**NSLPP MEETING HELD ON 04/10/23****Attachments:**

**ADDRESS/WARD:** 3-5 Morton Street, Wollstonecraft

**APPLICATION No:** DA 355/22

**PROPOSAL:** AMENDED PROPOSAL - Demolition of Two existing residential flat buildings and Construction of a New Residential Flat Building containing 28 Apartments, over two and a half levels of basement parking, plant and storage, associated works and landscaping.

**Figure 9. NSLEP 2013 Building height Plane compliance perspective. The northern side of the site is on the right side of this perspective.**

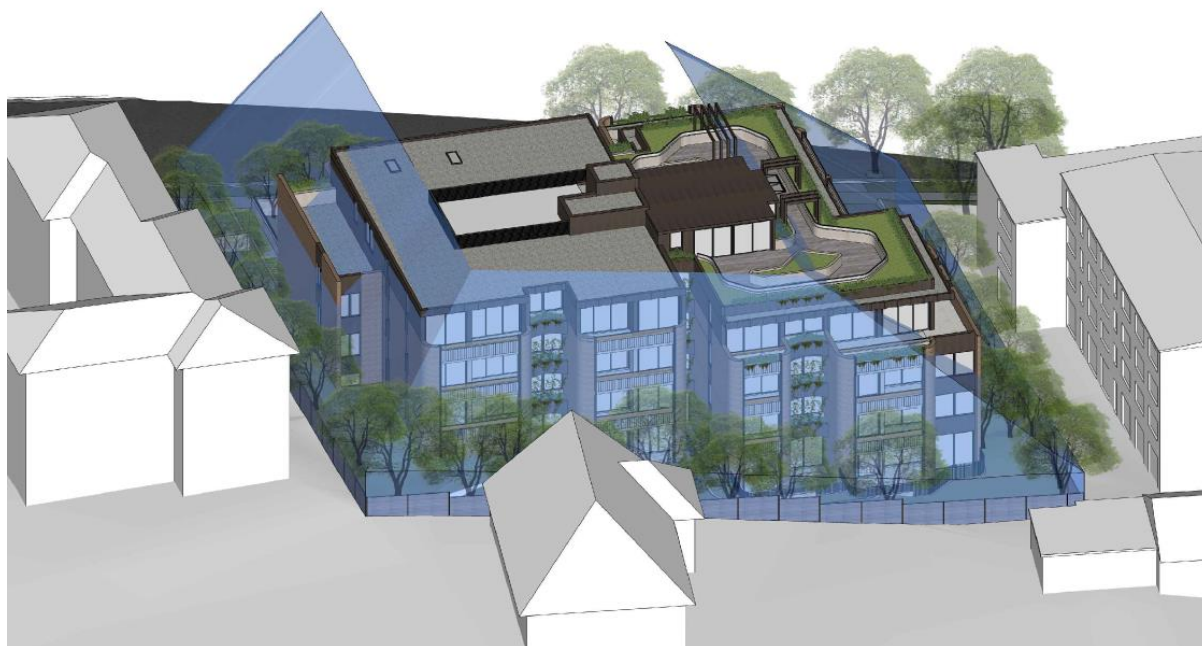
To detail the performance of the building at the upper levels with regard to Privacy, it is important do analyse the buildings performance with regard to Council's Building Height Plane control. The proposed building generally complies with the 45-degree building height plane as required under NSDCP 2013 and as can be seen by the compliance diagram provided in the design package (extract below) there are non-compliances at the upper levels in similar locations to the building height breaches.

Primarily the non-compliances encompass the rooftop communal space landscape planters and a portion of the northern fourth level secondary balcony area. Given the setback of the usable portion of the communal roof area, it is submitted that there are no adverse privacy impacts arising from this portion of the building. Regarding the level 4 northernmost apartment, the trafficable balcony on the north side is not the primary portion of the balcony which wraps around the apartment to the east. The living room to this apartment is orientated east with the great width portion on the east side of the building. Accordingly, should the panel determine there are potential privacy impacts at this point of the building, screening or restrictions to the use of the balcony on the northern side can be considered. It is however submitted that the eastern side of this balcony will be the primary used area.

It should be noted the southern side non-compliance is principally a non-trafficable roof space area and accordingly there is no adverse privacy impacts arising from this building height plane. On balance, the privacy impacts related to the building height and building height plane are submitted to be acceptable in the circumstances.
